G-3837

Subject: Response to September 3, 2015, Geotechnical Third Party Review Letter,
Proposed Residence, 5637 East Mercer Way, Mercer Island, Washington.

Reference: Geotechnical Third Party Review, 5637 E. Mercer Way, Mercer Island,
Washington (Perrone Consulting Project #15124). Perrone Consulting, Inc., P.S.,
September 3, 2015.

SUBSURFACE PROFILE A - A'

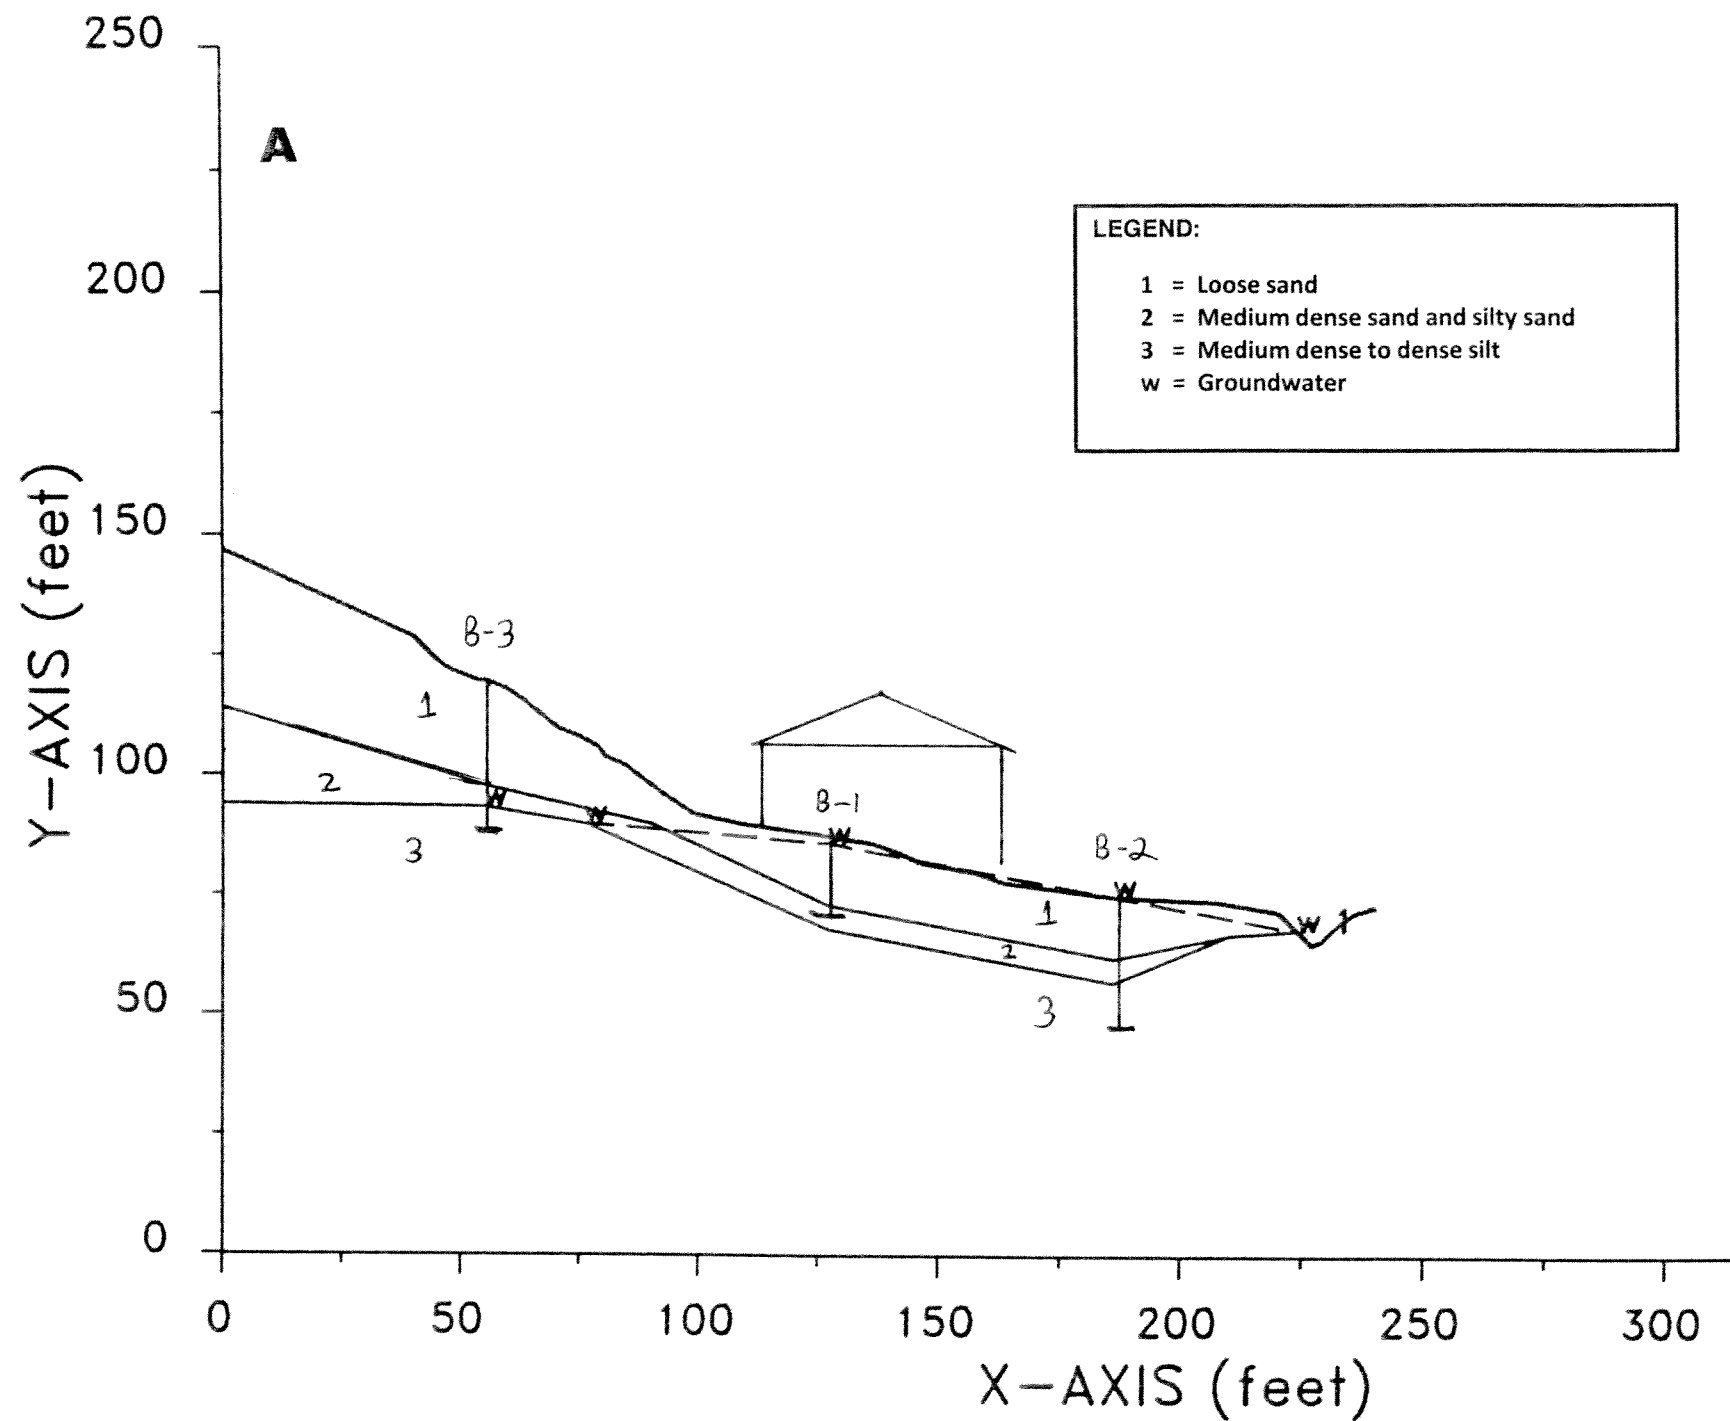
A site plan showing the locations of the soil borings previously completed on the site (B-1 and B-2) and the additional soil boring recently completed on the site (B-3) is provided in Plate 1 – Site Plan. Also, a subsurface profile through the site (the location of which is indicated on the site plan) is provided in Plate 2 – Subsurface Profile A-A’.

Stability analyses were performed for the site profile A-A' enclosed with this letter. The subsurface soil conditions illustrated in the profiles are based on the soil conditions logged for the borings drilled on site and our interpretation of the extent of those conditions into other portions of the profile. The interpreted soil conditions at locations other than at the boring locations are inferred based on our professional experience and judgment; the actual conditions may vary from those represented in the profile.

The stability analysis calculations indicate that the slope profile has an FS value of 1.26 for stability in its existing configuration for the static case, and an FS value of 0.94 for the seismic case. The most critical failure surfaces for the existing slope condition consist of arc-shaped failures that involve the loose sand soils. These failure surfaces are generally similar for the static and seismic cases. The most critical failure surfaces identified in the analyses are illustrated in the analysis plots provided in Attachment 2.

Based upon the results from the subsurface investigation and slope stability analysis that we have completed, it is our opinion that the steep slope in proximity to the proposed residence location is relatively stable in its current condition. However, based on the observed conditions, it is our opinion that the slope is susceptible to shallow raveling or sloughing, particularly if it is disturbed by earthwork or significant clearing. With regard to larger-scale movement, we concluded that the slope has a low potential for failure in its existing condition over the short term. However, there is the potential for failure of the loose sandy soils in the slope over the long term, particularly during high-intensity seismic events or if exceptionally high groundwater levels develop in the sandy soils up the slope.

5637 E MERCER WY
10 most critical surfaces, MINIMUM BISHOP FOS = 1.263

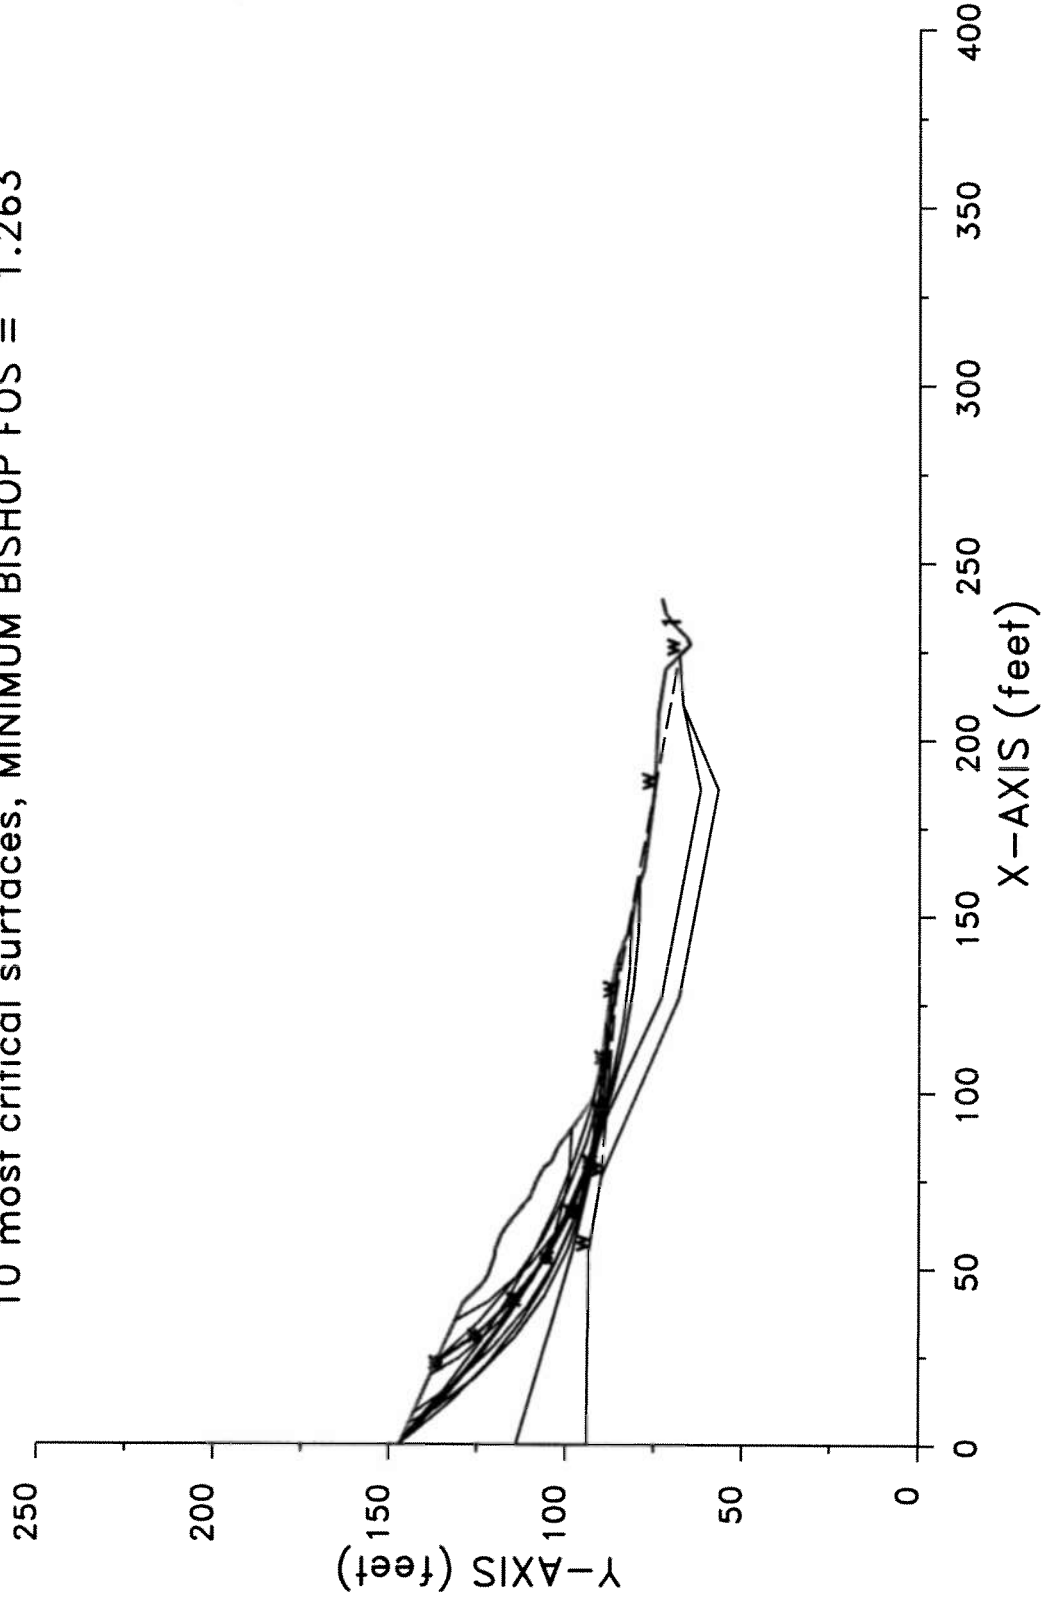
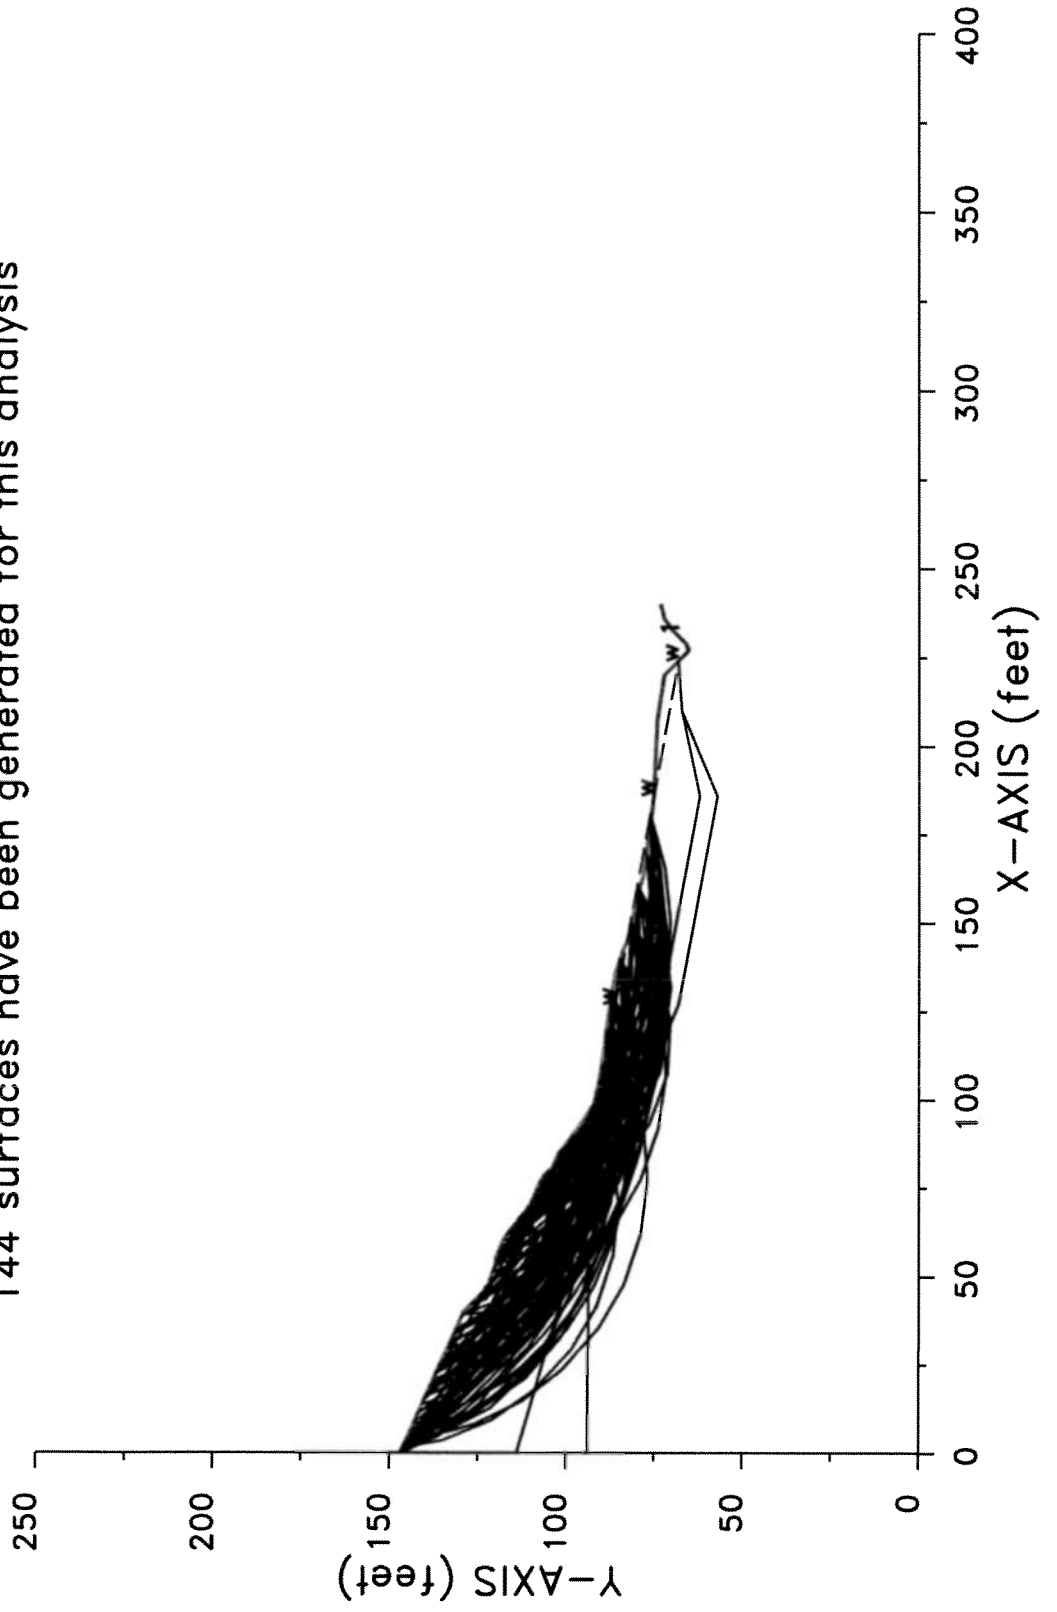
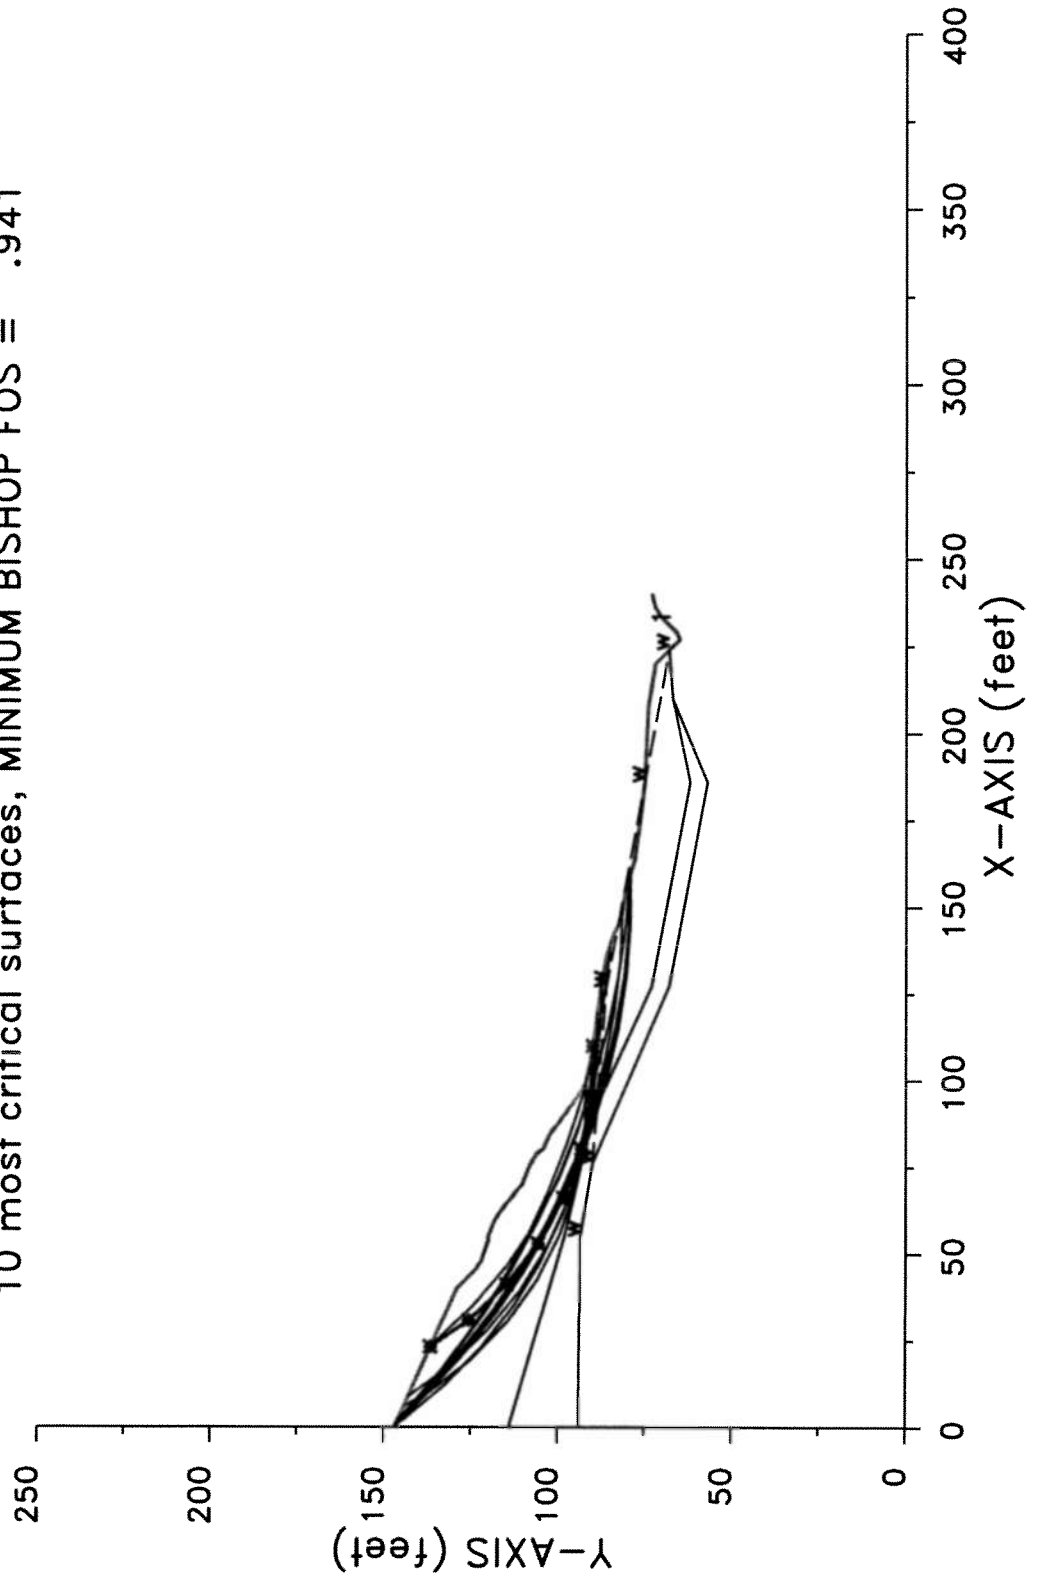
Analysis Results
